This Addendum is hereby made a part of the Contract Documents to the same extent as though it were originally included therein.

END OF ARCHITECTURAL ADDENDUM NO. 1

SALK MIDDLE SCHOOL GYMNASIUM REPLACEMENT

CE-01

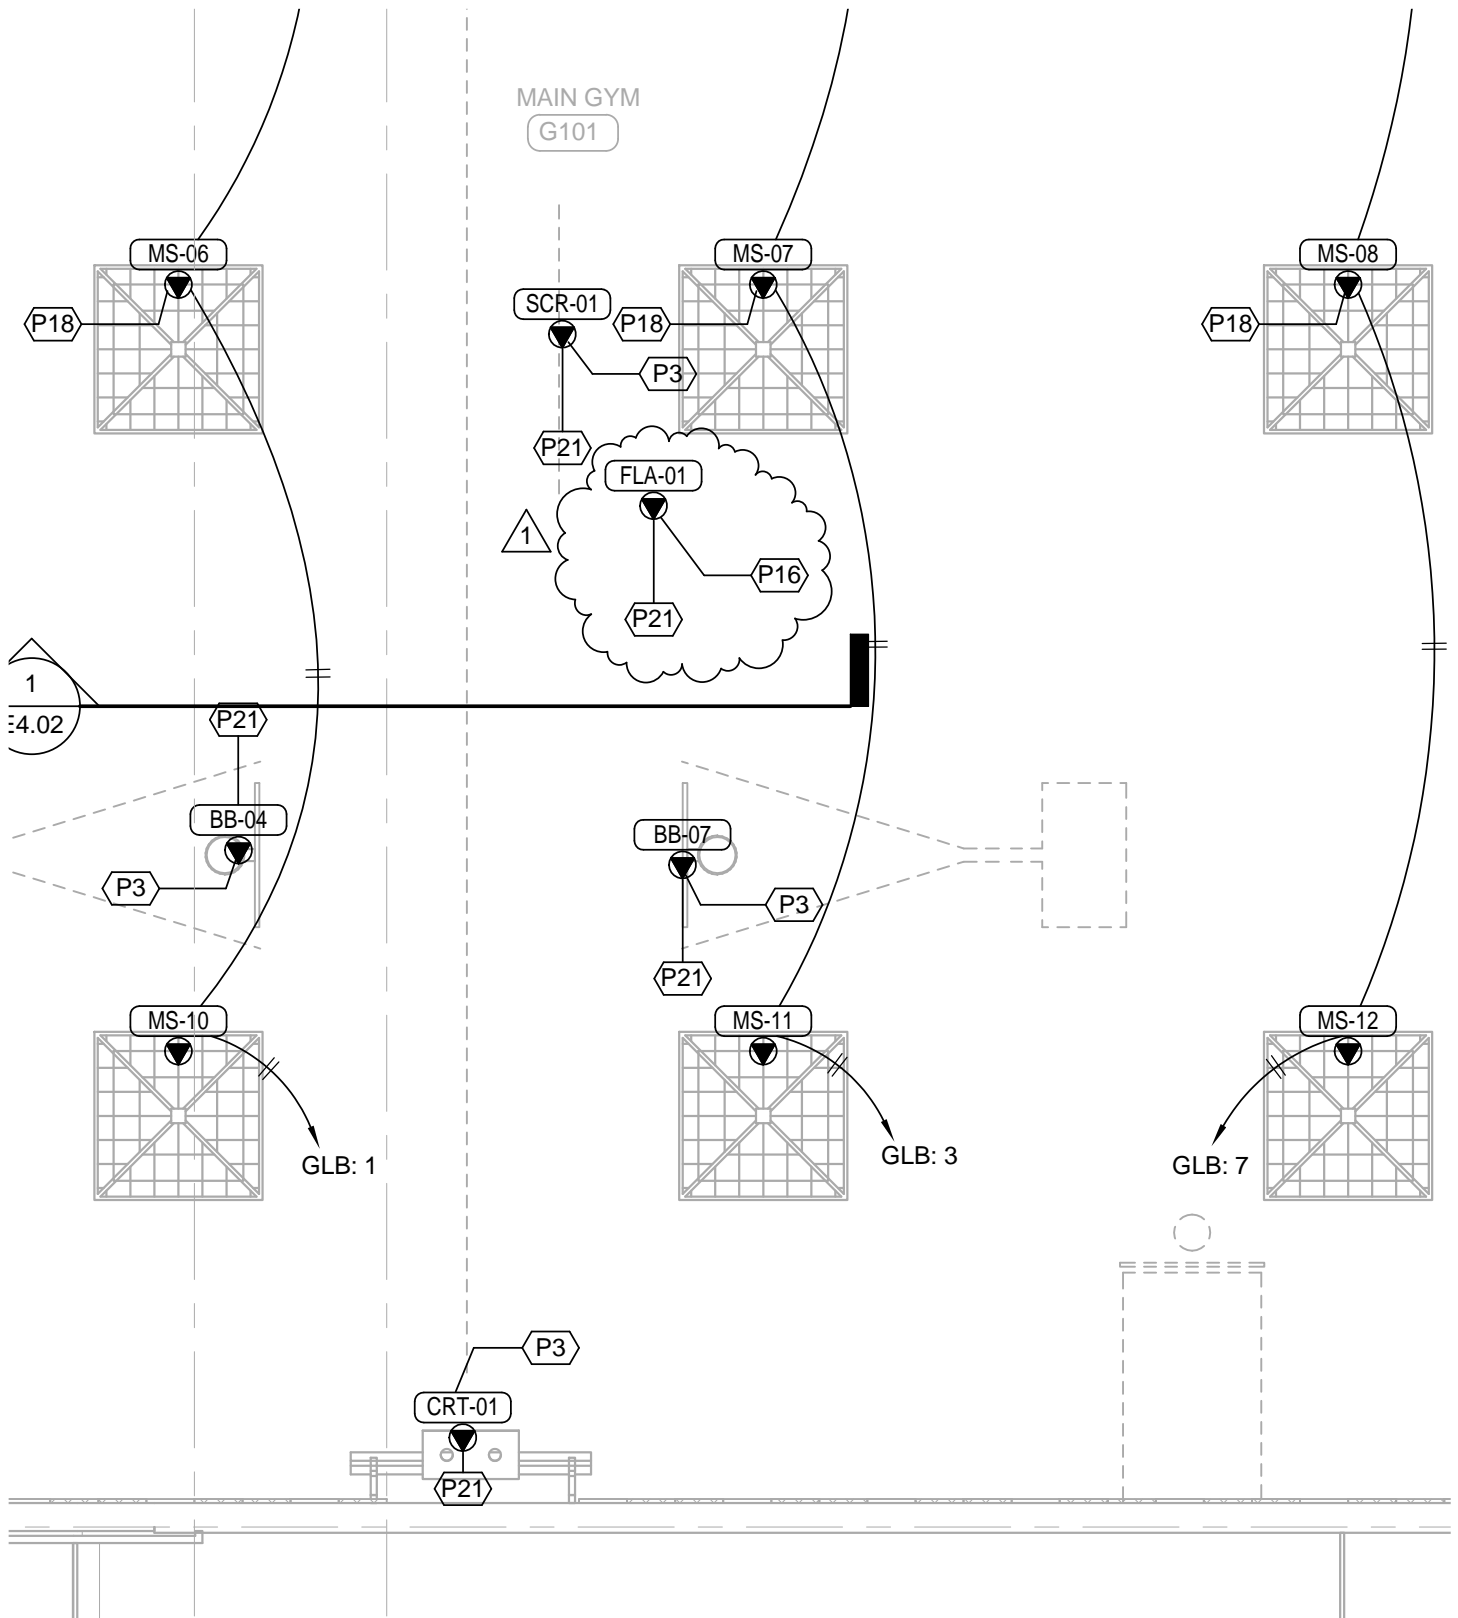
ADD: Make electrical connections to flag roller in room G101 per Electrical Keynote P16. See drawing CE-01

CE-02

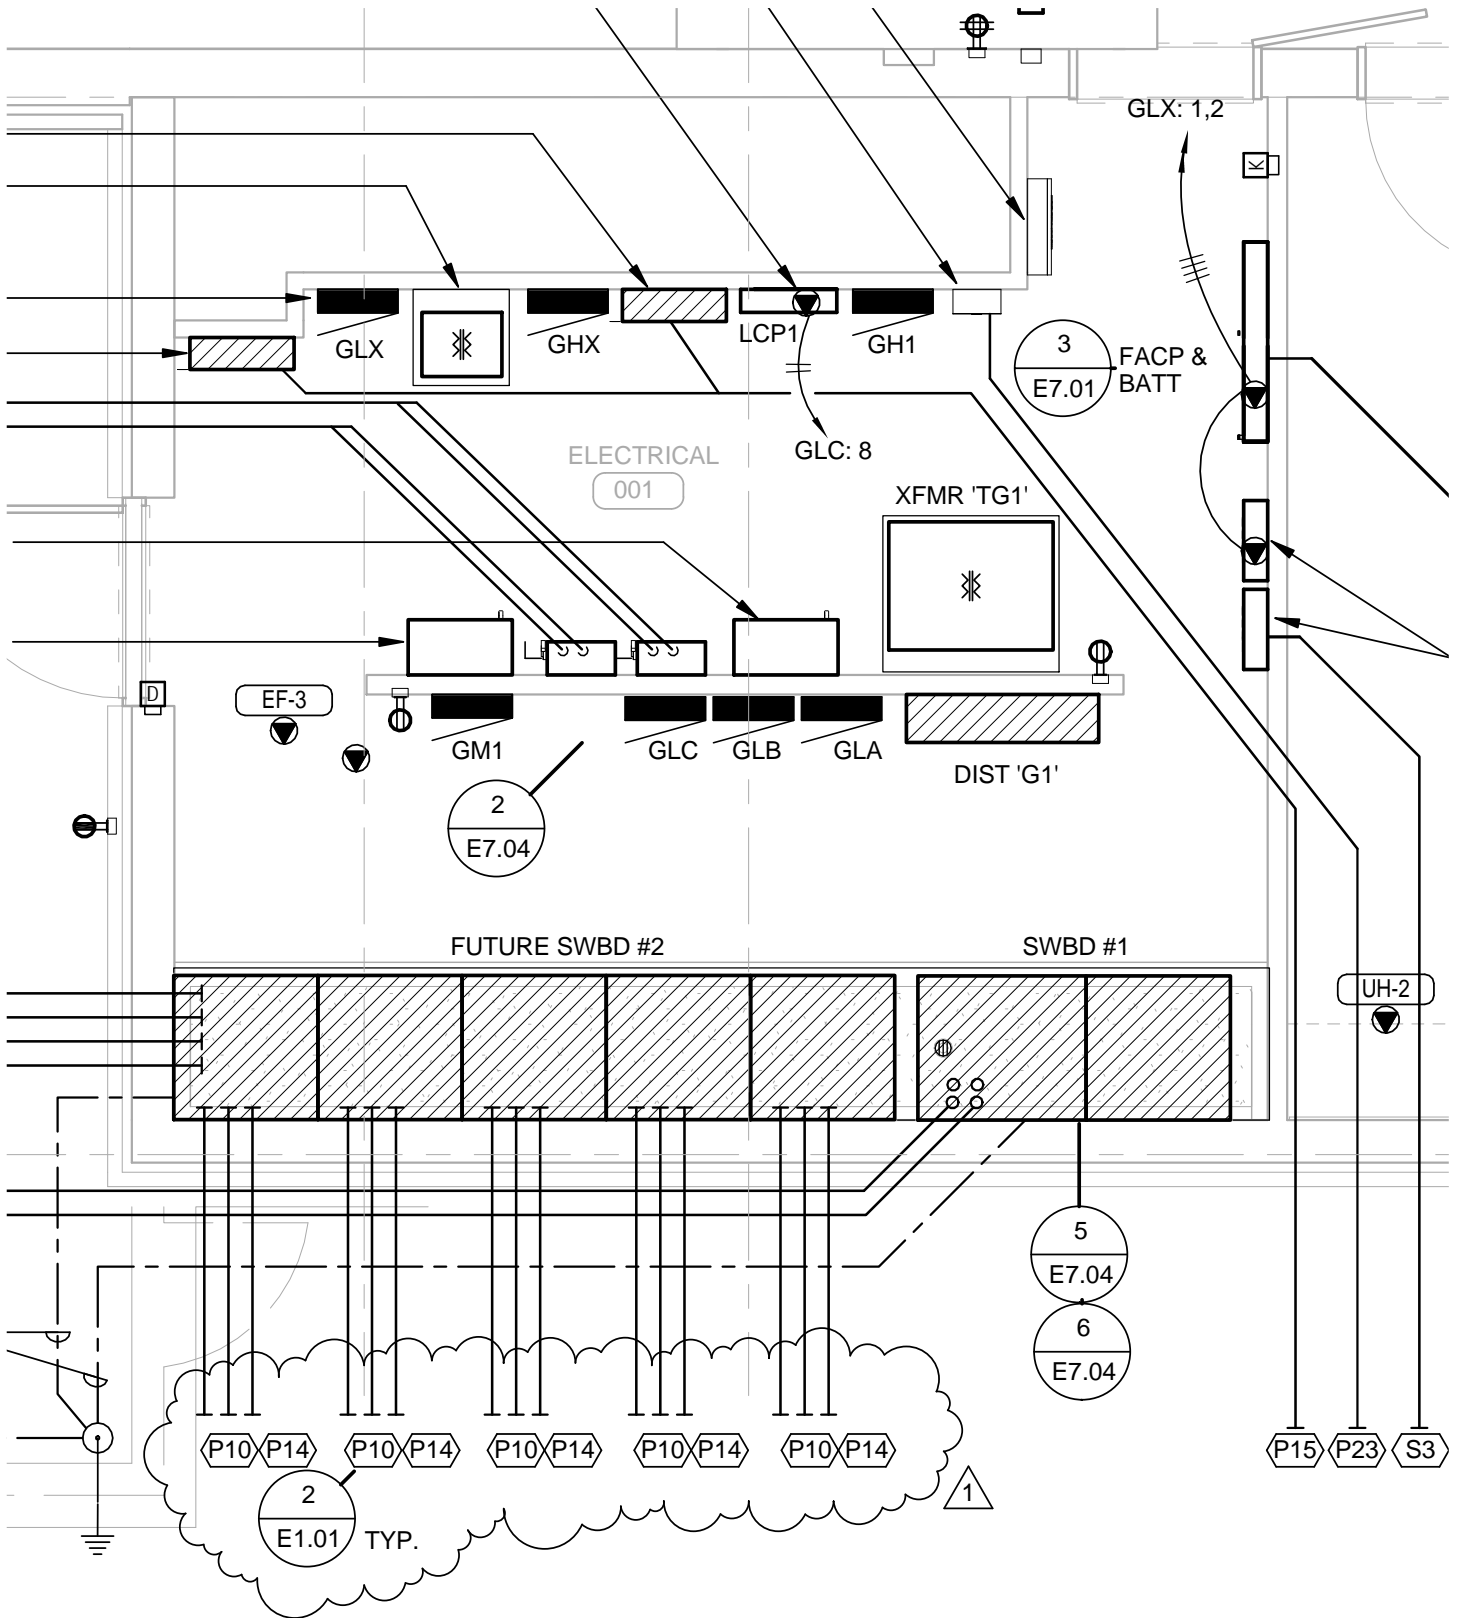
ADD: Raceways noted as "STUB-OUT FOR FUTURE" shall be install as indicated in Electrical Keynote P14 and Electrical Keynote P10 on drawing E5.01. See drawing CE-02.
